# **Safety Evaluation Report**

related to the construction of the  
**Clinch River Breeder Reactor Plant**

Docket No. 50-537

**U.S. Nuclear Regulatory  
Commission**

Figure A.1 Energy absorbed by head

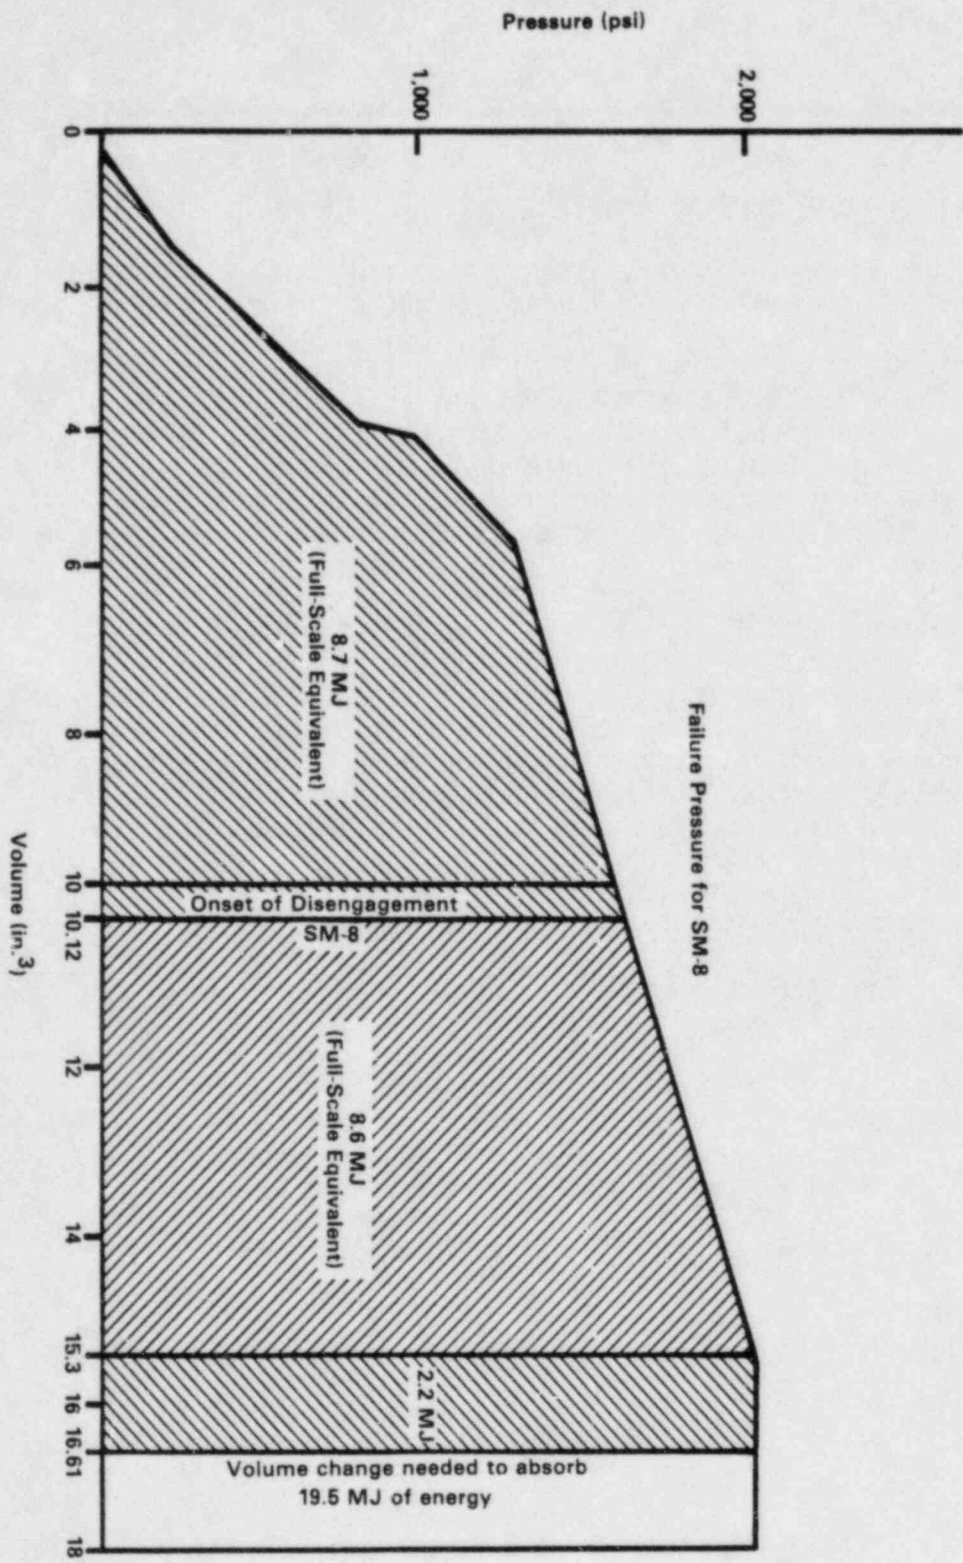
To estimate displacement needed to absorb 20 MJ of energy we used the pressure-volume curve for the SM-8 hydrostatic test and extend the relation as a straight line (constant pressure) beyond the previous failure volume. Integrating under this curve we determined that the head must deflect enough to give a volume of 16.6 in.<sup>3</sup> (Reference 3). This is equivalent to a maximum deflection of 0.24 in. (4.7 in. for the fullscale head), which is well below the deflection that would cause disengagement with the modified head (approximately 8 in.).

Based on the applicants' study and the staff's consultants calculations performed at Los Alamos the staff believes that the vessel head, with the proposed modifications as discussed in Enclosure 1 of the applicants' letter dated February 14, 1983 titled Sodium Slug Energy Absorption Capability of a Modified CRBR Closure Head, will have the capability for withstanding an impact of a slug with 75 MJ of kinetic energy. This will be confirmed by the applicants through development of scale models and static and dynamic tests (SM-9 and SM-10). The staff requests that water released through the head on test SM-10 be measured.
